Appendix I: Comments and Responses

This appendix provides responses to public and agency comments on the American River Common Features (ARCF), 2016 Flood Risk Management Project Draft Supplemental Environmental Impact Statement/Subsequent Environmental Report (SEIS/SEIR) received during the public comment period for the Draft SEIS/SEIR.

Figure 9. ARMS One Inlet Backwater Concept

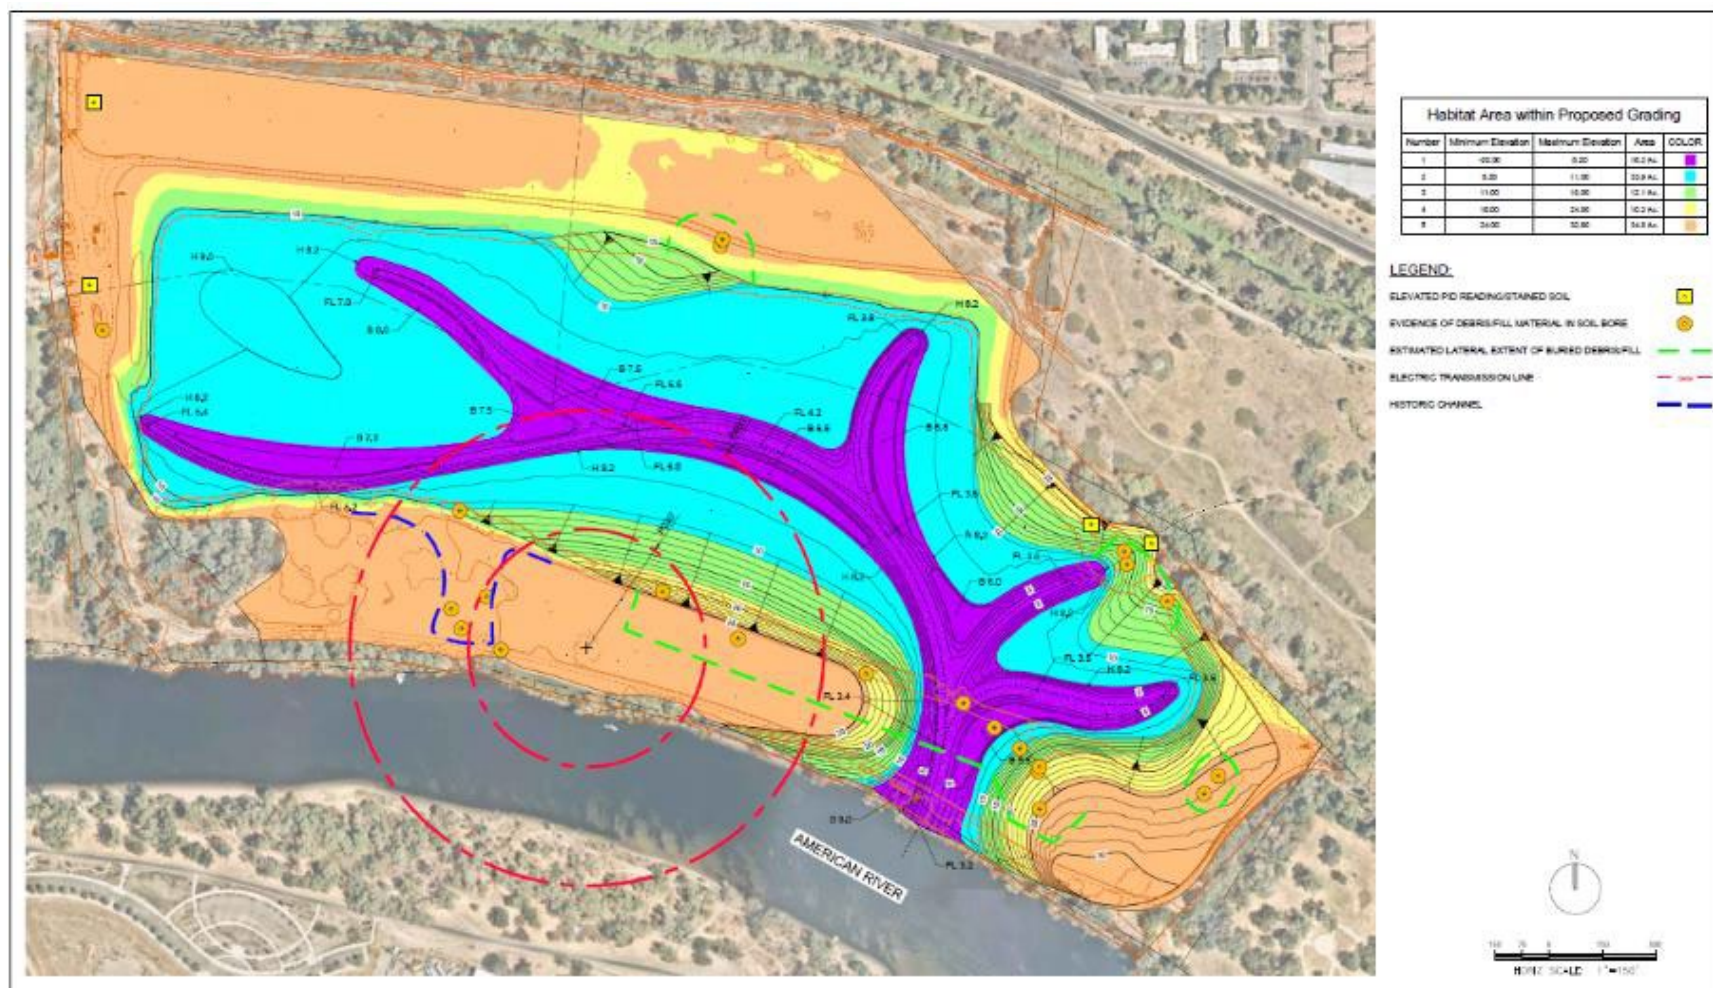
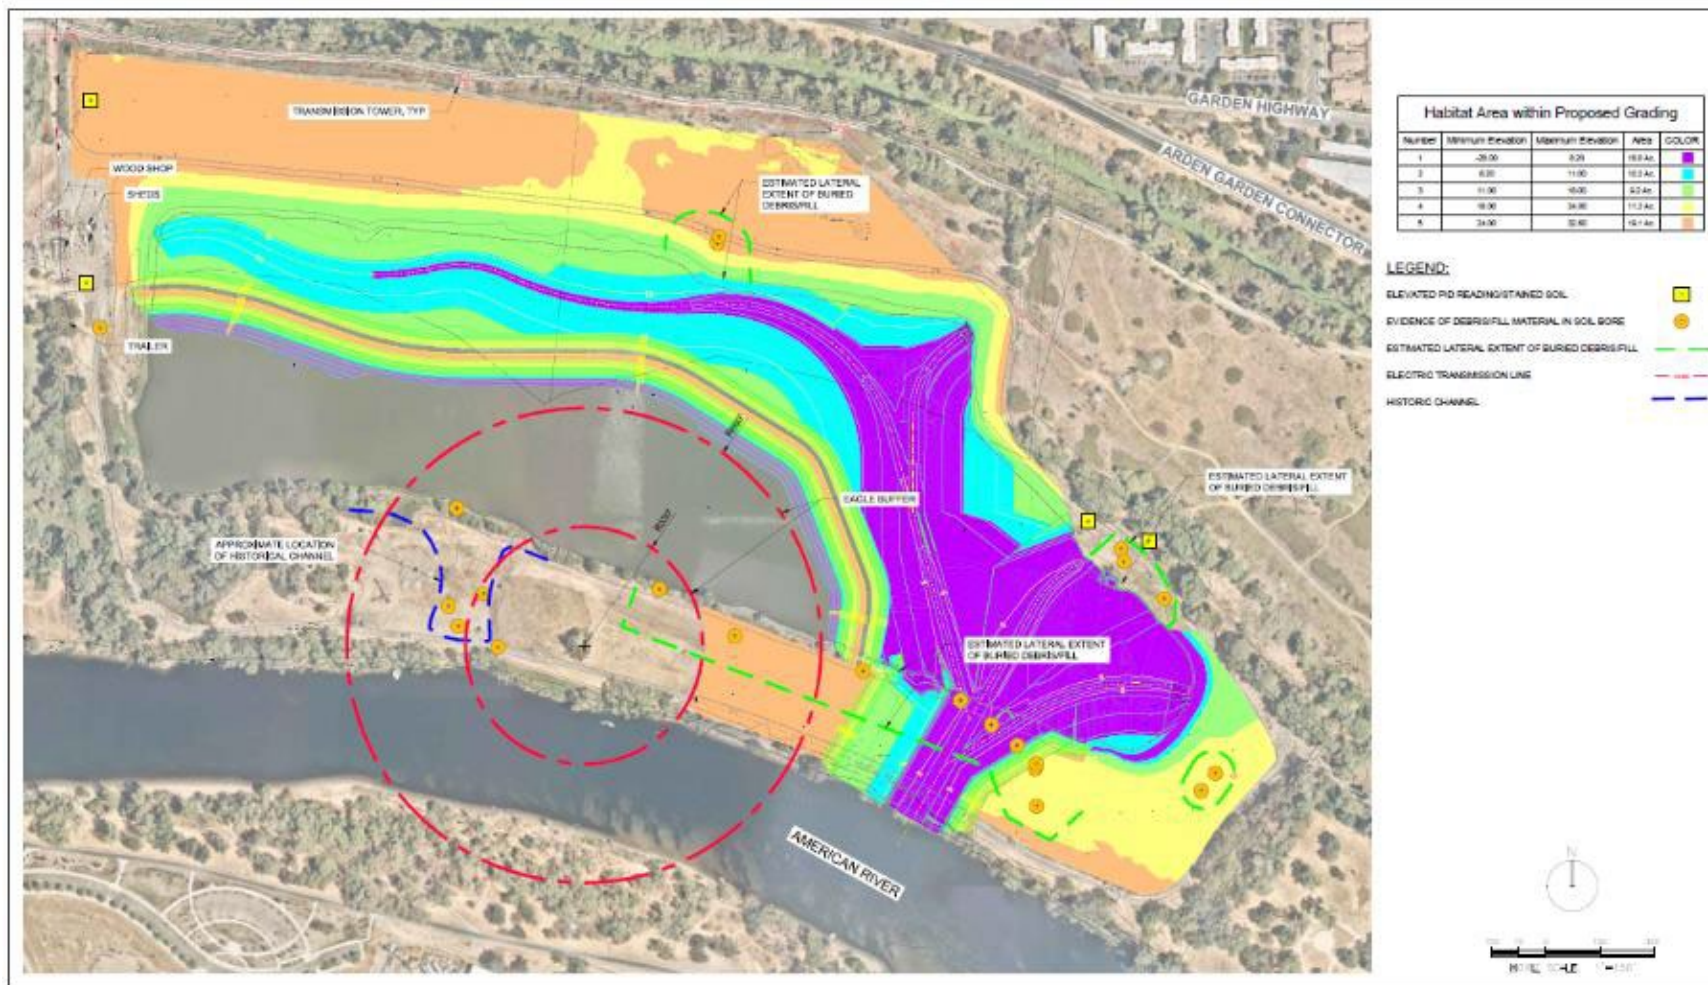
Retention of a portion of the pond post-project would maintain a stranding risk for salmonids, as well as create preferred habitat conditions (i.e., slow flowing, deep water) for non-native predatory fishes that negatively impact native salmonid populations. In addition, the portion of the pond remaining would need to have the existing debris and materials capped to address any public health and safety concerns associated with potential post-project recreational activities, as well as generate increased long-term maintenance challenges associated with the berm, vegetation removal, sedimentation, and water quality. The concept that proposes to restore the entire pond to riverine and riparian habitat generates the needed compensatory mitigation acreages, has the greatest minimization of salmonid stranding risk, maximizes habitat value for

special-status species, and aligns with the Parkway Plan and NRMP. Therefore, the project design team removed the concept retaining the pond from further consideration because it did not meet the project objectives.

Figure 12. Anticipated Post-Construction Hydrograph

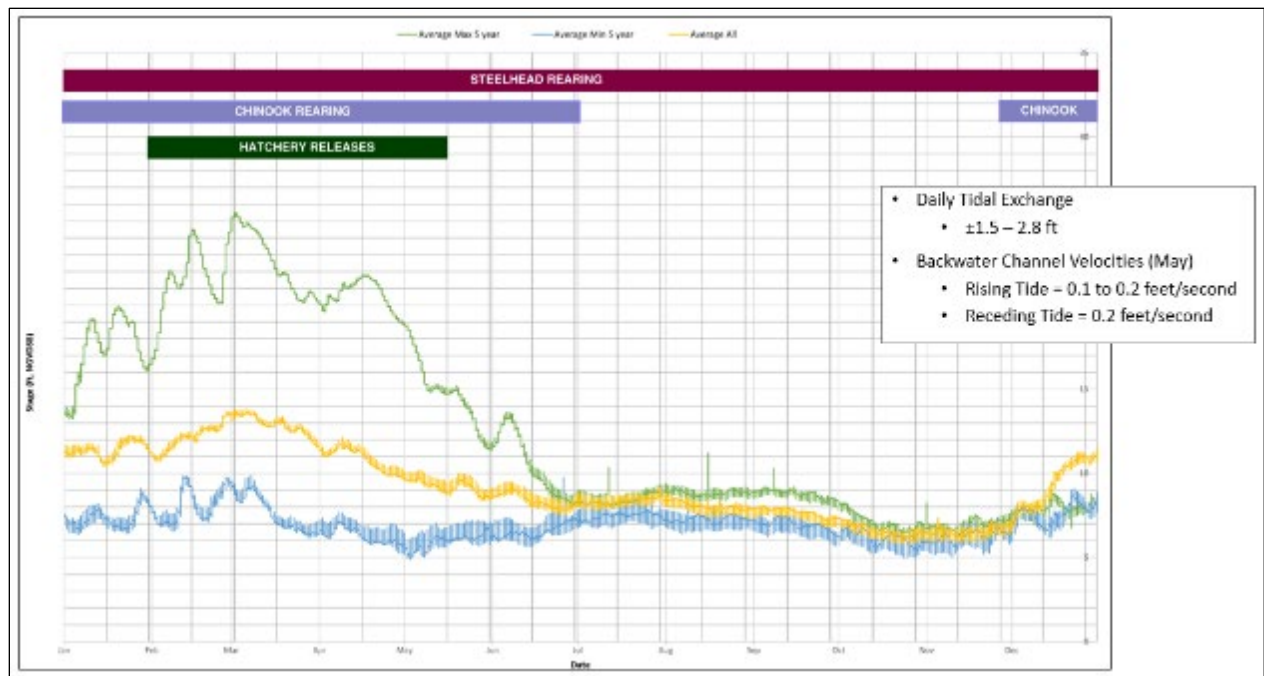
Figure 12 shows the anticipated post-construction hydrograph based on 20 years of WSE data in which all data were analyzed to create an average stage elevation curve, for comparison with an average of the highest 5 years of stage data and the lowest 5 years to generate curves for high and low water conditions. As can be seen in Figure 12, the average annual high-water elevation is 15 feet NAVD 88, which would typically occur in March, and an average low between 6 feet and 7 feet NAVD 88 from mid-October to early December, at which point the WSE would begin to rise. Depths of 0 to 20 feet and velocities of 0 to 0.2 feet/second were calculated by the hydraulic model throughout the backwater channel for likely flow of 3,900 cubic feet per second and stages 4.6 feet to 23.72 feet. Daily tidal exchange ranges are also estimated at 1.5 to 2.8 feet. These data, along with reference site observations, were used to inform the design elevations and habitat zones.

Figure 27. ARCF 2016 Project Erosion Protection Improvements on LAR

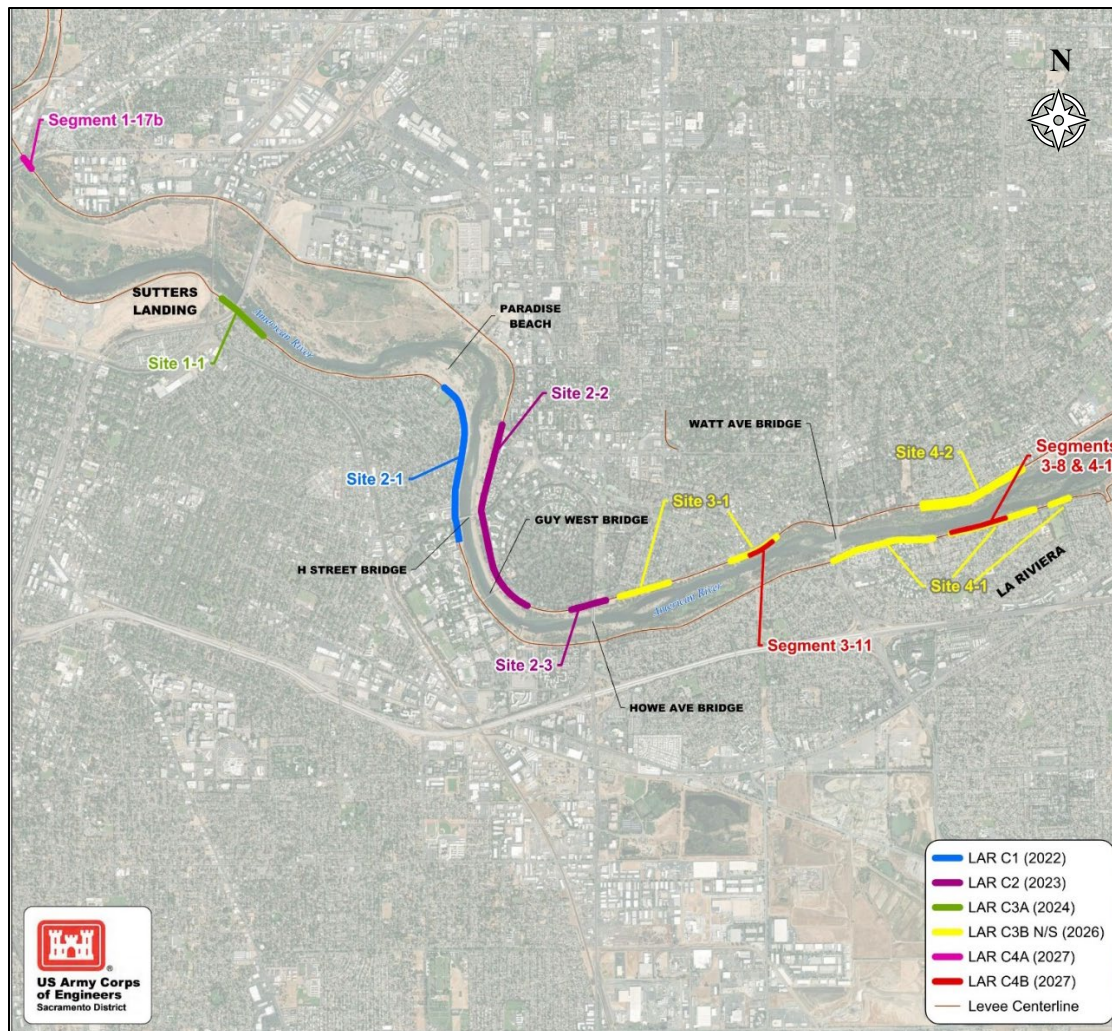
American River Erosion Contract 4B is located on the right (north) bank upstream of Howe Avenue and on the left (south) bank upstream of Watt Avenue. Contract 4B is located immediately adjacent to Contract 3B; specifically, in between the footprint of Contract 3B and the levee crown. Figure 1 shows the location of Contract 4B in relation to the locations of the other ARCF 2016 Project erosion protection improvements along the LAR. Contract 4B is focused on addressing two key erosion risks along the Lower American River, specifically in river Segment 3-11 on the north bank upstream of Howe Avenue and Segments 3-8 and 4-1 on the south bank upstream of Watt Avenue. The first erosion risk being addressed by Contract 4B pertains to lone tree scour which is detailed in Section 2 below. The second erosion risk Contract 4B is addressing is the potential for erosion to outflank the Contract 3B design is Segment 4-1 on the south bank of the river; this second erosion risk is detail in Section 3 below.

Figure 32. Contract 3B Tiebacks

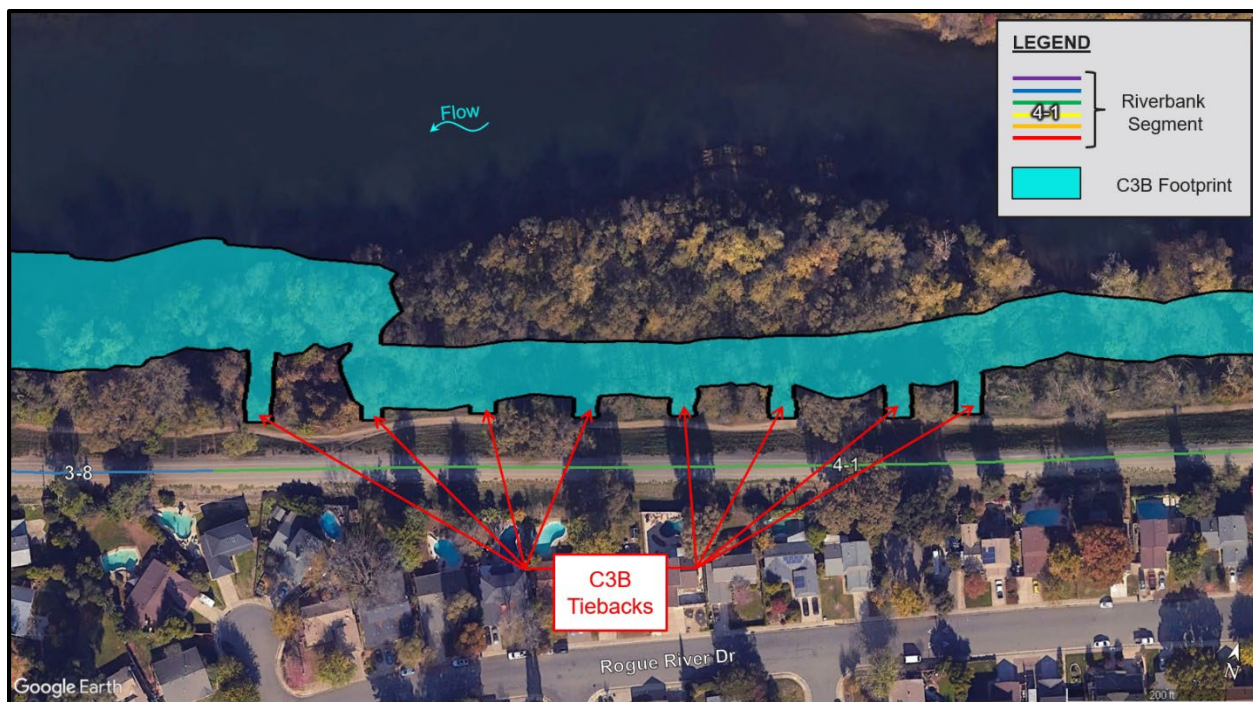
Within Contract 3B Segment 4-1 on the south bank of LAR, upstream of Watt Avenue, part of the erosion protection planned includes installation of rock tiebacks which serve to prevent erosion from outflanking the revetment installed at the riverbank's edge (i.e., eroding the bank/levee landward of the riverbank's edge revetment). These tiebacks can be seen in Figure 32 below. The locations of these tiebacks were selected to avoid impacts to existing vegetation and were intended to extend further landward into the VFZ to ensure the tiebacks ability to prevent erosion from outflanking the Contract 3B bank revetement; however, due to concerns which arose late in the design development phase of Contract 3B the tiebacks were cut short to avoid encroaching into the vegetation free zone. The concerns were specific to working in and around the vegetation which exists within the VFZ which could trigger the need for, and USACEHQ approval of, a VDD. Given the time requirements to develop and get approval of a VDD, as further described in Section 2.4 above, it was decided to stop the Contract 3B tiebacks outside the VFZ and construct the remaining extent of the tiebacks under Contract 4B which was already planning on developing a VDD to support preservation of trees identified as a lone tree scour risk described in Section 2.

Figure 35. American River Contract 3B Upstream Protected and Removed Trees

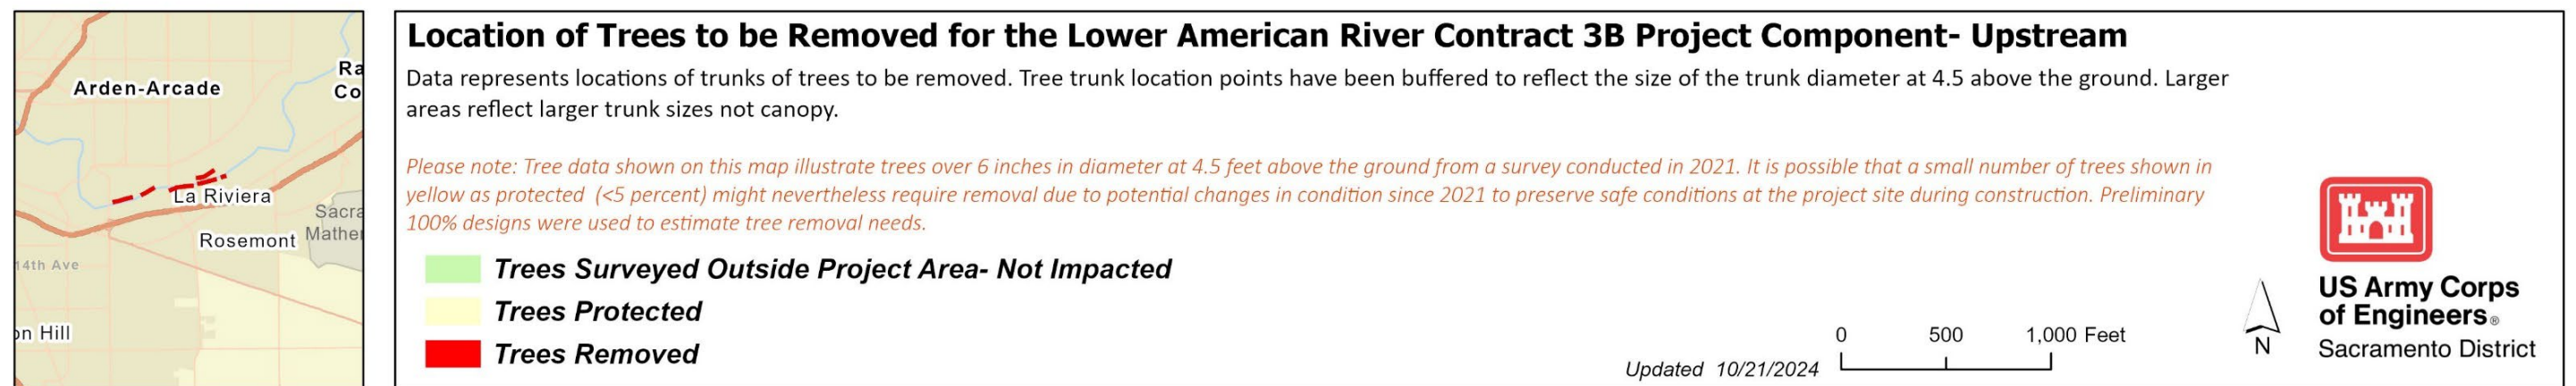
Tree trimming would be completed, where necessary, to avoid damaging trees adjacent to construction access, staging, and bank protection improvement areas. Tree removal and trimming would be completed within appropriate work windows. Any tree removal or trimming occurring within protected areas or outside of the work windows would be completed under the supervision of a qualified arborist/ecologist. Coordination with Sacramento County Regional Parks (Regional Parks) would continue throughout the design and construction processes for consistency and compliance with the tree preservation and protection ordinance (Title 19, Chapter 19.12⁴¹).
